ADMINISTRATIVE SITE PLAN APPROVAL

PROJECT INFORMATION										
Project Title	Heart Saved Enhanced Services Facility				Date of Report	October 6, 2022				
File Number	PA22-036				Attachments	Approved Site Plan (Exhibit 024) MDNS (Exhibit 026)				
Administrative Recommendation	Approve the preliminary commercial site plan, subject to the conditions of approval contained in Section 2.0.									
BACKGROUND SUMMARY										
Applicant	Heart Saved Adult Family Home, LLC									
Request	Administrative Site Plan Approval in order to construct a two-story commercial building, housing a 16-bed Enhanced Services Facility (ESF) on the second floor and office/retail on the first floor, and associated site improvements.									
SEPA Status	A Mitigated Determination of Non-significance was issued on September 15, 2022 (Exhibit 026). Appeal period expired September 29, 2022. No appeals were filed.									
Site Address	8619 36 th Avenue NE			APN(s)	00459600000202

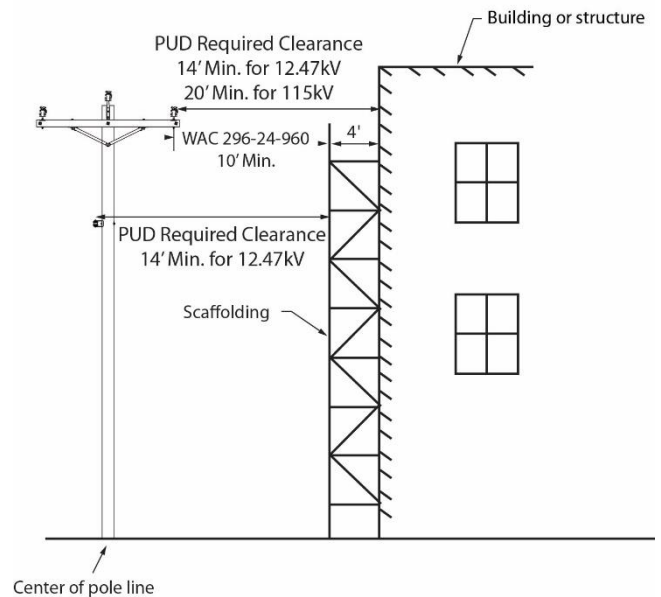
- a. Marysville Fire District: *Sprinkler room appears acceptable for sprinkler riser and alarm panel. Access meeting city code requirements for aerial fire apparatus access may be required. The front drive aisle may provide the access required. See MMC 9.04.503.1.5.*

Plans do not show proposed water main extension. Plans show a new fire hydrant along the south side of the drive aisle, off the center of the building. Hydrant location is good. Water main extension with approved fire hydrants onsite will be required. The building sprinkler system FDC is required to be located within 3' to 10' from a fire hydrant.

The City GIS water map shows a 12" water main in the roadway, with existing fire hydrants located along the west side of the road, about 100' apart. The spacing of existing fire hydrants meets current fire code requirements for this use. Maximum 300' apart is allowed for MF use.

No information about available fire flow is provided for the fire hydrants near this site. The minimum fire flow required for the site is 1,500 gpm. Contact the city water dept. for flow test.

14. Access planned appears adequate for fire apparatus. The drive aisle access width that is shown is 26' access appears adequate. A minimum 26 feet wide fire apparatus access is required in the immediate vicinity of any building more than 30 feet in height for ladder truck operations, and within 20 feet on both sides of fire hydrants.

15. Turnaround provision is required for dead-end access in excess of 150 feet long.
